SUBJECT: Forwards response to NRC 820121 request for addl info re
 proposed license amend for removal of boron injection tank.
 Info provided re LOFTRAN analyses, proposed hardware mods &
 reactivity feedback results.

Re: Turkey Point Units 3 & 4
Docket Nos. 50-250 & 50-251
Proposed License Amendment
Removal of Boron Injection Tank

ATTACHMENT

Fig. 2 Hot Leg Entrance Temperature For Typical Steam Line Break

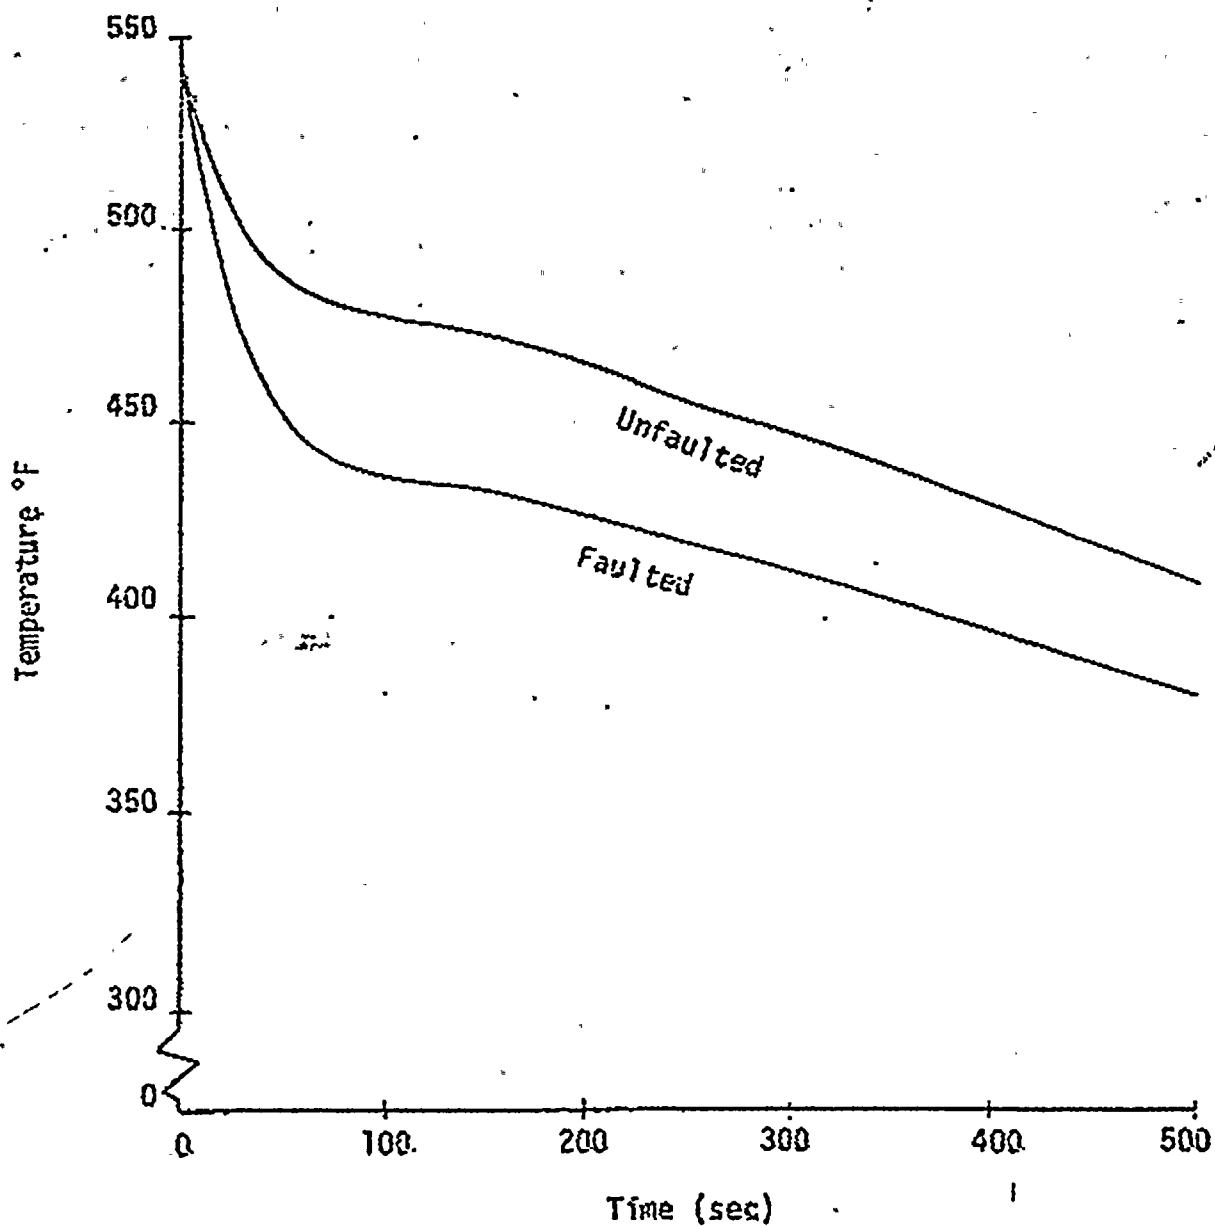
Q 6: It is our understanding that LOFTRAN thermal-hydraulically homogenizes (assumes perfect mixing) the reactor coolant entering the vessel from the broken and intact recirculation loops. This assumption provides identical hot leg temperatures for all loops. Of concern is that the broken loop cold leg temperature may be non-conservatively elevated since the broken loop hot leg temperature could be appreciably lower than analyzed. Should this be the case, then the moderator temperature at the stuck rod location would be non-conservatively analyzed. Justify your analytical model with regard to the above concern.

A 6: Because LOFTRAN is a multiloop PWR simulation code, provision has been made to allow coolant to mix among the loops in the reactor vessel inlet and outlet plena. Independent inputs for the inlet and outlet are available to vary the extent of mixing between no mixing and perfect mixing. The loop-associated core inlet and core average parameters must be combined into a single reactivity feedback input for use in the point kinetic core model. This is accomplished by a separate weighting factor which places relative importance on specified sectors of the core, thus enabling LOFTRAN to predict reactivities which are in agreement with multi-dimensional neutron design codes.

To show the modeling capability of LOFTRAN, the exit temperature in the cold leg and entrance temperature of the hot leg, for both faulted and unfaulted loops, are presented in Figs. 1 and 2, respectively. Figure 3 presents the basic fluid system model utilized by LOFTRAN (refer to WCAP-7878).
